## Product Change Notice (PCN)

PCN Number: **PCN-0450972R-02**

Product(s) Affected: *SJ1-351XN Series. (SJ1-3513N, SJ1-3514N, SJ1-3515N)*

PREVIOUS CUI DEVICES DETAIL / IMAGE			NEW CUI DEVICES DETAIL / IMAGE

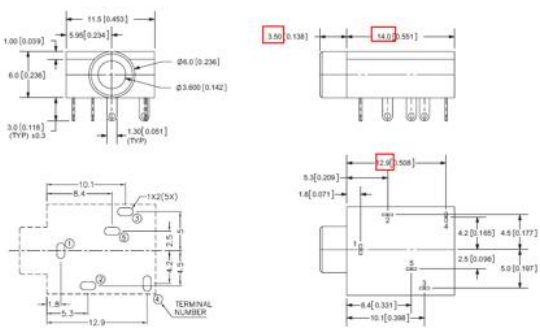
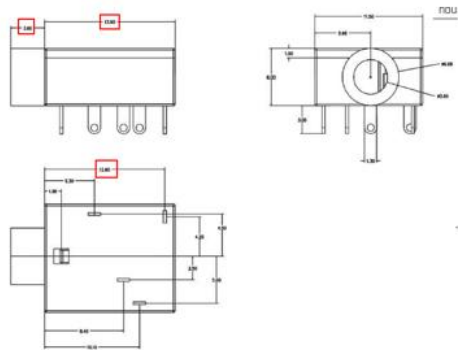
Description of Change: *Slight Dimensional difference. Terminal Material Change See image Below*

MATERIAL	PLATING	DESCRIPTION	MATERIAL	PLATING/COLOR
terminal 1	brass	silver	terminal 1	brass t=0.3	silver
terminal 2	brass	silver	terminal 2	phosphor bronze t=0.3	silver
terminal 3	brass	silver	terminal 3	brass t=0.3	silver
terminal 4	brass	silver	terminal 4	brass t=0.3	silver
terminal 5	brass	silver	terminal 5	phosphor bronze t=0.3	silver
bushing	brass	nickel	bushing	brass	nickel
spring	stainless steel		spring	steel	black
cover	PBT		cover	PBT (UL94V-0)	black
plastic	PBT		housing	PBT (UL94V-0)	black
